## **Timestamp Inaccuracy Due to Idle Insert/Delete for AMs**

IEEE 802.3 Geneva, Switzerland January 2020

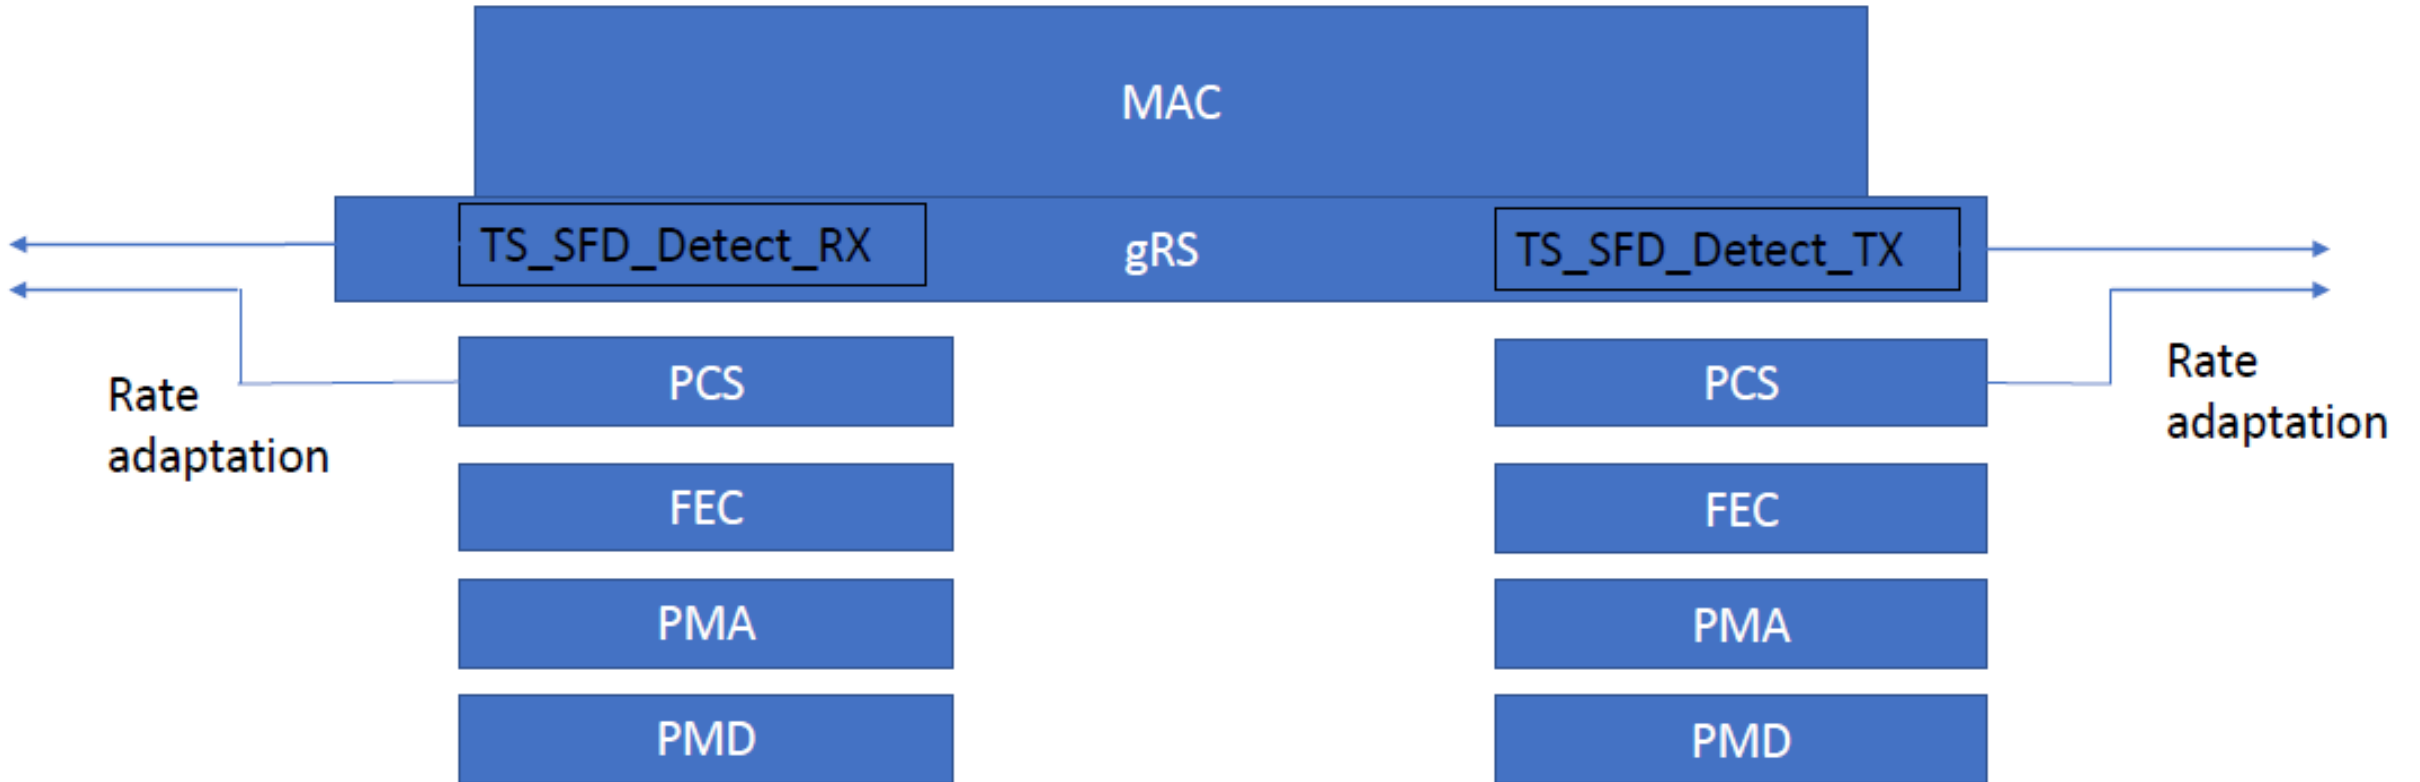
- Add the text following Clause 90.7 paragraph 2 as proposed in nicholl\_nea\_01\_190416.pdf, with some of the proposed edits of parkholm\_itsa\_01\_0120:

- For a PHY that inserts alignment markers or performs rate adaptation [for the purpose of AM insertion](#), the transmit path data delay measurement starting point (the beginning of the first symbol after the SFD at the xMII input) should be adjusted to account for alignment marker insertion or rate adaptation that occurs in the PHY (between the xMII input and the MDI output) which impacts the relative location of the beginning of the first symbol after the SFD. Based on this adjustment, the result is a transmit path data delay measurement that appears as if the alignment marker insertion or rate adaptation [for the purpose of AM insertion](#) had been performed before the Tx xMII. Similarly, the receive path data delay measurement ending point (the beginning of the first symbol after the SFD at the xMII input) should be adjusted to account for any alignment markers or rate adaptation [for the purpose of AM removal](#) that occurred in the PHY (between the MDI input and xMII output) which impacts the relative location of the beginning of the first symbol after the SFD. Based on this adjustment, the result is a receive path data delay measurement that appears as if the alignment marker [removal](#) or rate adaptation [for the purpose of AM removal](#) had been performed after the xMII.

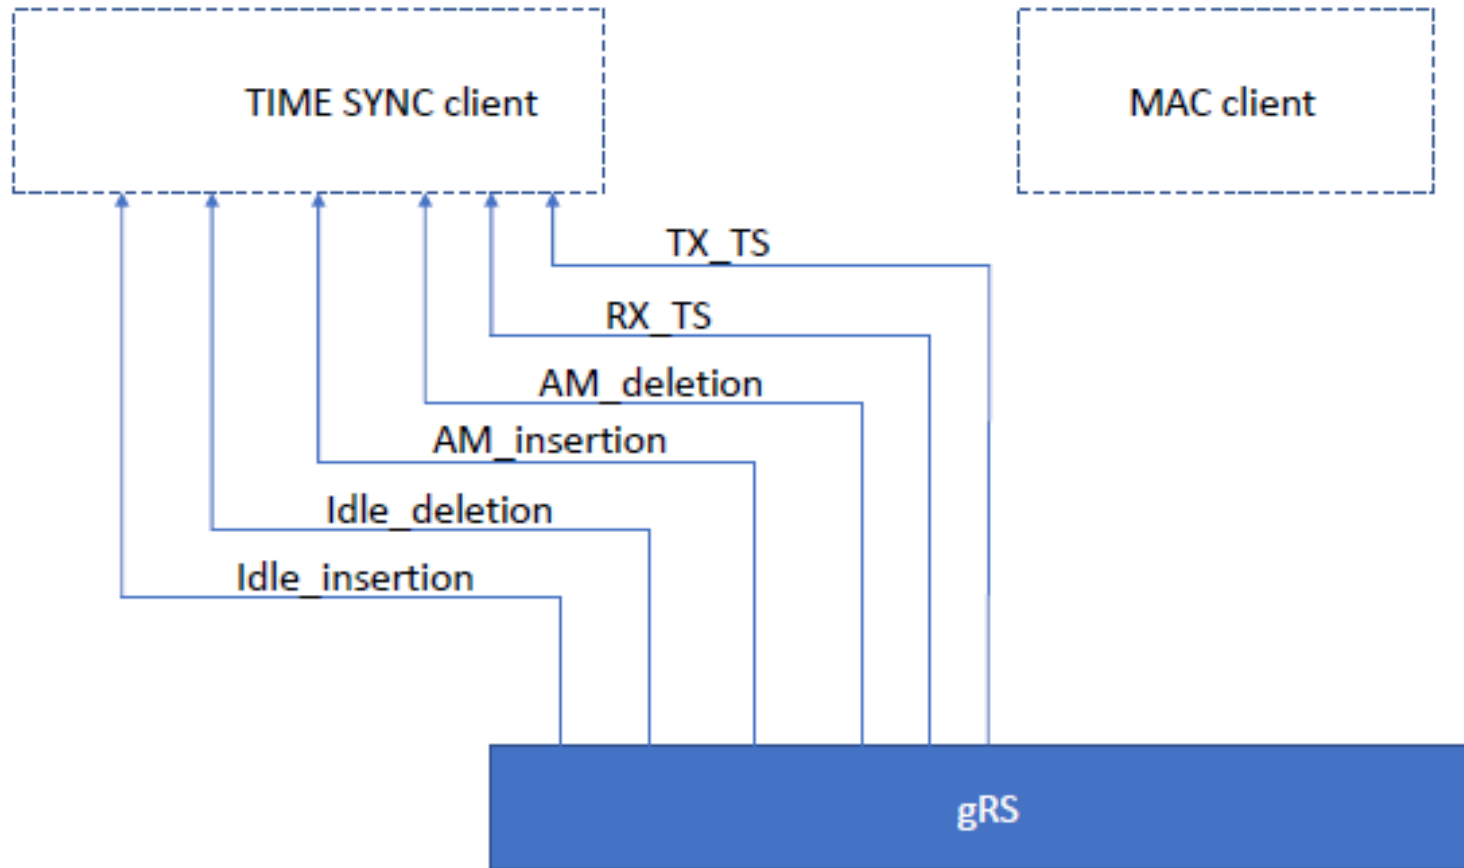
- Consistent with the proposed amended text, include a figure equivalent to the modified Figure 90-3 and text, per parkholm\_itsa\_01\_0120, to show the additional information that needs to be passed from the PHY to the TIME SYNC CLIENT through the gRS layer on a packet-to-packet basis:

- The rate adaptation signals in the TSSI would add to describing the proper handling of AM insertion/deletion and/or Idle.
- These signals would take on the value of TRUE when the corresponding event has been performed within the PHY.
- Possible primitives
  - AM\_deletion.indication
  - AM\_insertion.indication
  - Idle\_deletion.indication
  - Idle\_insertion.indication
